HOMWOOD SUITES

3500 S. MERIDIAN

07-15-21	CITY COMMENTS
11-05-21	CITY & FRUITLAND MUTUAL WATER COMMENTS

OVERALL SITE PLAN

STORM UTILITY PLAN
C-4.1

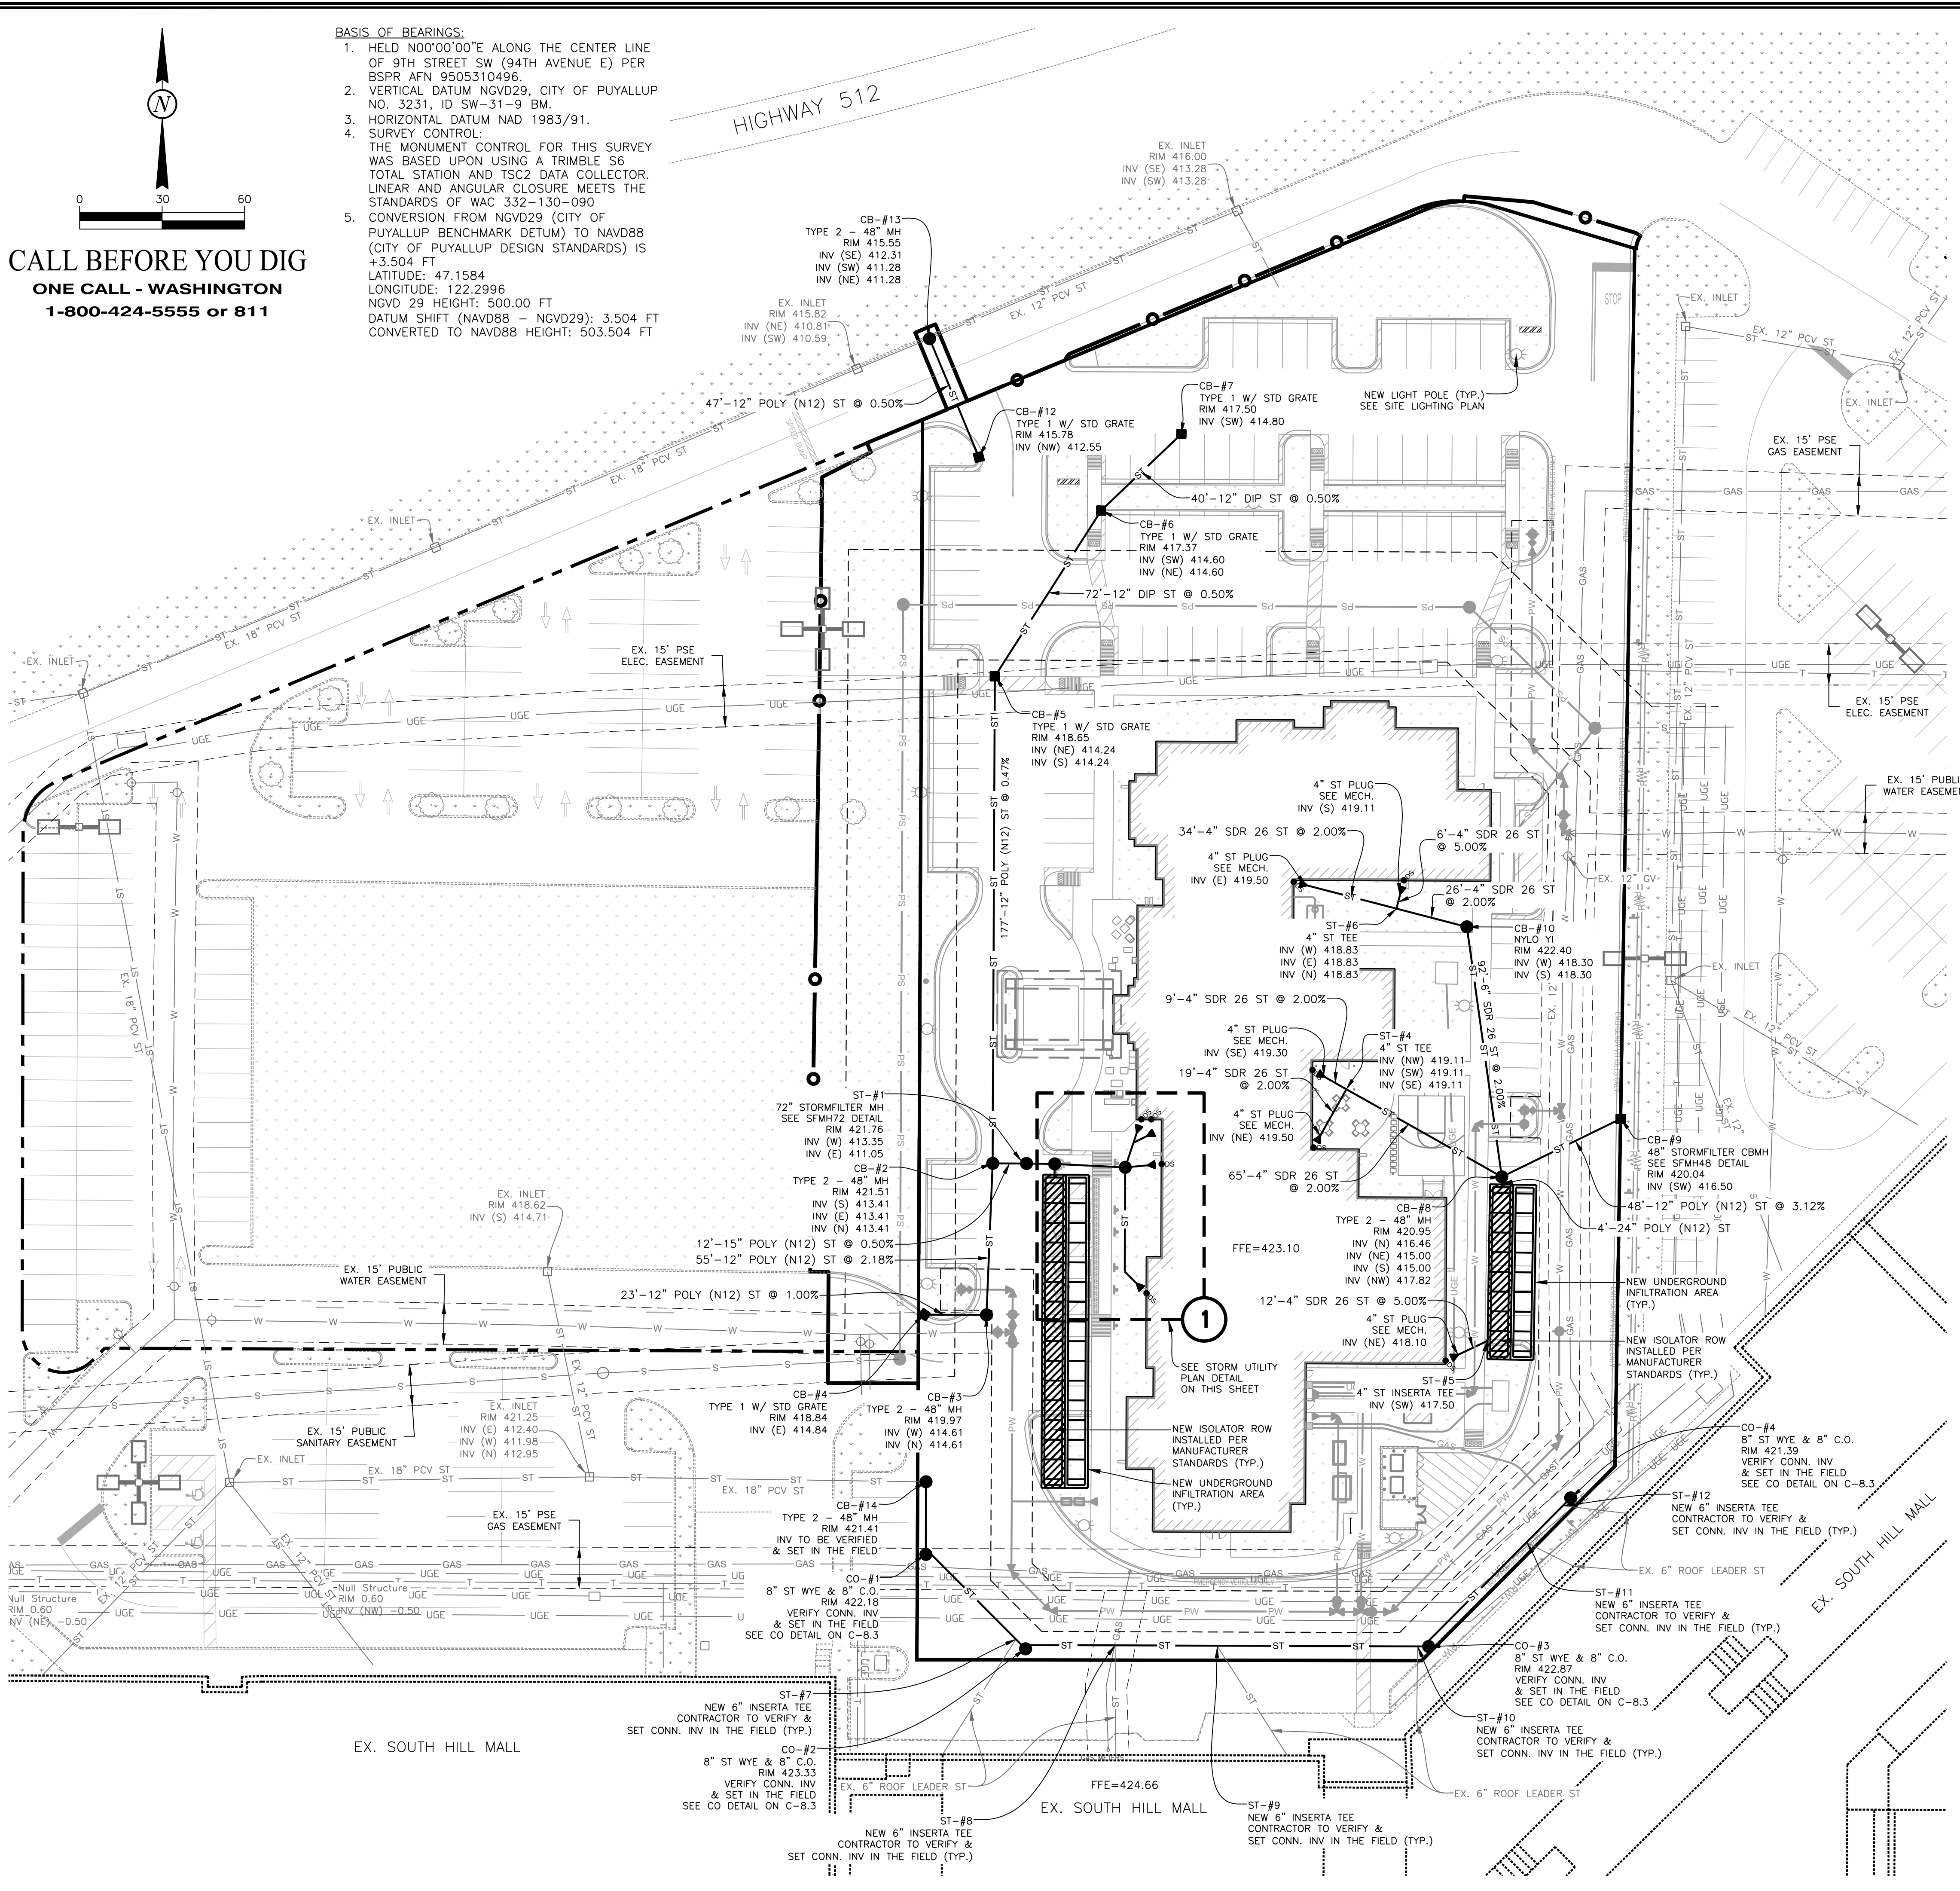
- CITY COMMENTS - 07-13-21**
- UPDATED STORM UTILITY PLANS TO COORDINATE WITH THE STORMWATER ENGINEER'S DESIGN/CALCULATIONS
 - ADDED CoP APPROVAL STAMP
- CITY & WATER COMMENTS - 11-05-21**
- UPDATED STORM UTILITY PLANS TO COORDINATE WITH THE STORMWATER ENGINEER'S DESIGN/CALCULATIONS
 - UPDATED THE ESTIMATED STORM QUANTITIES PER THE STORM UPDATES
